8XC196KB AUTOMOTIVE APPLICATION SPECIFICATION UPDATE

Release Date: November, 1996

Order Number: 272970-001

Figure 1. Quasi-bidirectional Port Circuit

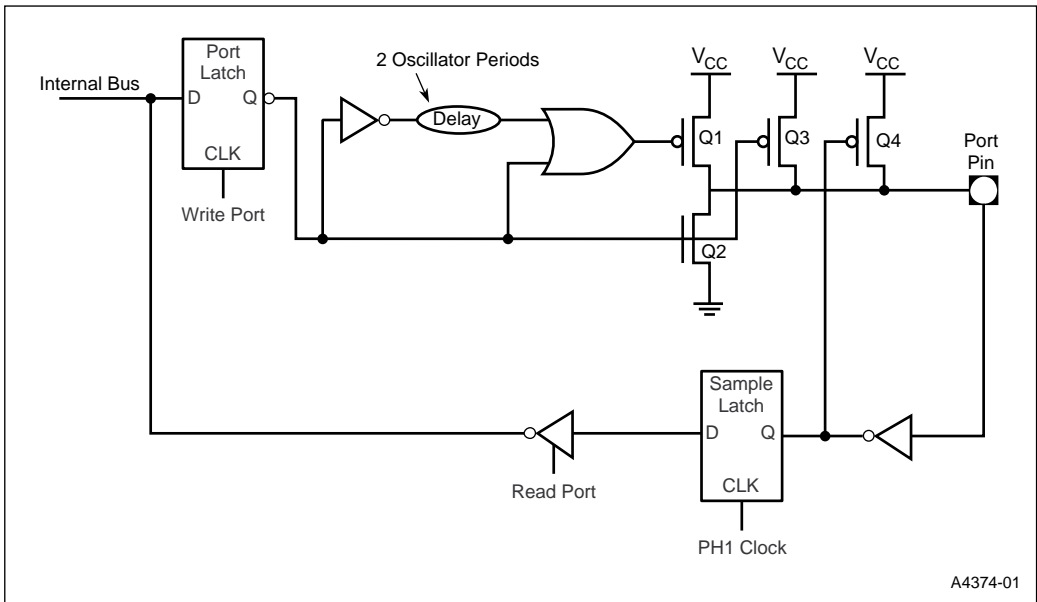
001. I_{TL} Specification Changed to -800 μA (from -650 μA)

PROBLEM: The specification for I_{TL} on the 8XC198 and 8XC196KB/8XC196KB16 devices has changed from -650 μA to -800 μA to meet the device characteristics at low temperatures.

The I_{TL} specification is the maximum current that the 8XC196KB quasi-bidirectional pins can source during the transition from a logic 1 to a logic 0 input. Figure 1 shows the quasi-bidirectional port circuit. When the port is configured as an input, the output of the port latch is a '0'. Therefore, Q3 is weakly pulling the port pin high. When the external circuitry drives the pin high, Q4 also is turned on and holds the port pin signal high. As the external circuitry decreases the voltage below V_{CC} toward logic 0, Q4 begins to turn off. However, due to transistor characteristics, Q4 will source increasing amounts of current until the threshold voltage of the transistor is reached. Then, Q4 will turn off, leaving only Q3 driving the port pin signal high.

IMPLICATION: Customers using the quasi-bidirectional pins as input should analyze their applications to see if their external circuitry can handle 80 μ A of current from the quasi-bidirectional pins during the transition period described above.

Figure 2. Quasi-bidirectional Port DC Characteristics ("1" Written to Port Pin)

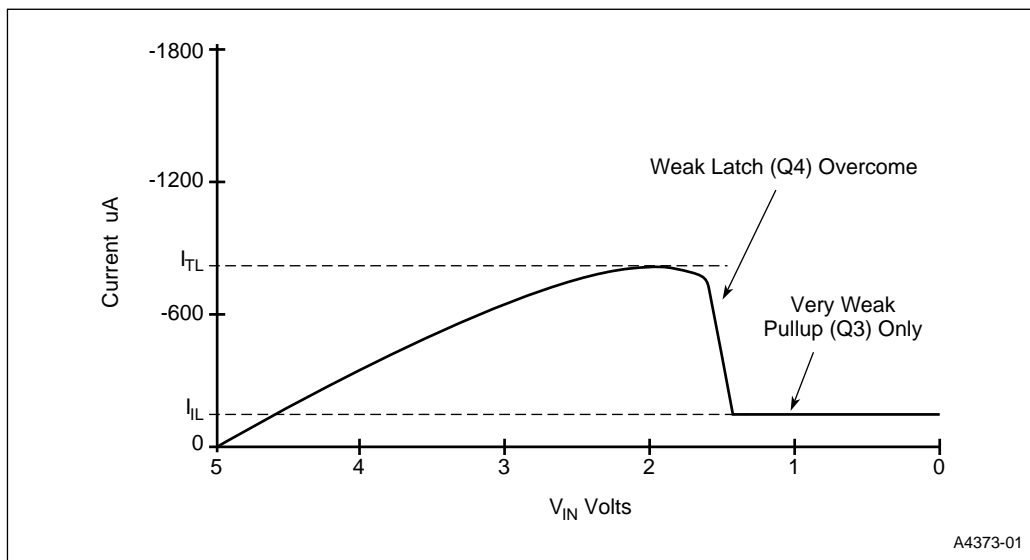
Figure 2 shows the transfer characteristic of the port pin during the input's transition from logic 1 to logic 0. The I_{IL} specification shows the amount of current Q3 will source after Q4 turns off. The I_{TL} specification gives the maximum amount of current that Q4 will source during the input's transition from logic 1 to logic 0.

Figure 3. Improved System Reset Circuit

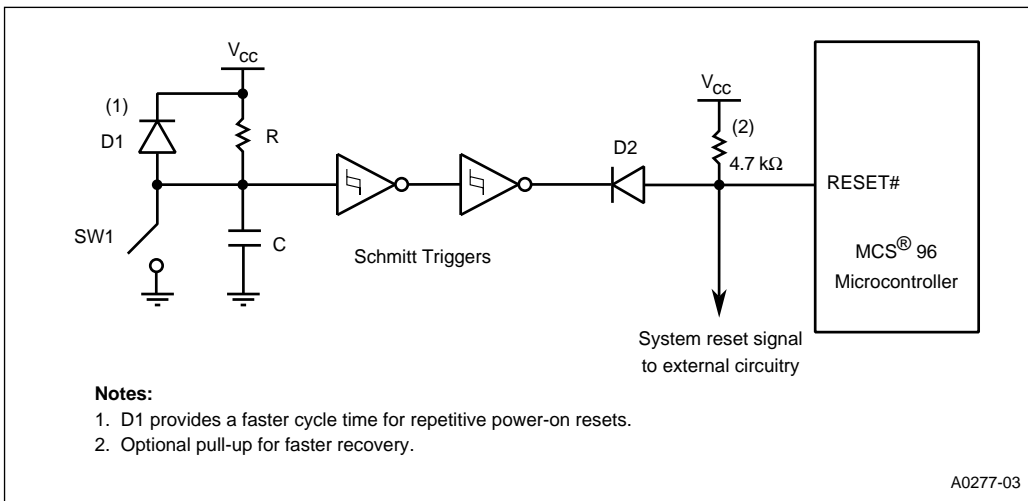
PROBLEM: The following improved system reset circuit shown in Figure 3 may be used in conjunction with the *80C196KB User's Guide* (270651-003).

The system reset circuit in the *80C196KB User's Guide* has been used successfully by many customers for a long period of time. Both circuits should be evaluated in the user's system.

The main difference between the two circuits is the addition of a 4.7 KΩ pull-up resistor. In some systems, the internal pull-up resistor on the RESET# pin is not sufficient, resulting in a slow rise time. Therefore, the external pull-up resistor was added to allow a more predictable rise time on the RESET# input. The external pull-up resistor is optional, but it may help ensure a clean reset, either for the 8XC196KB or for the external system.

The improved system reset circuit will be included in the next revision of the *80C196KB User's Guide*.
